ADA Curb Ramp New Construction Inspection Form (Parallel)

NW Timeric

23885.56

NW North

PARALLEL RAMP (PL)

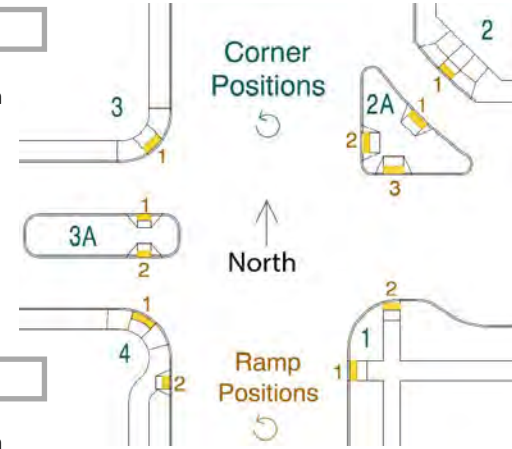
4.3 $\leq *$ ☐ $> *$ ☒

7.3 $\leq 2.0\%$ ☐ $> 2.0\%$ ☒

9.7 $\leq 2.0\%$ ☐ $> 2.0\%$ ☒

NTD RR1 TS Fail
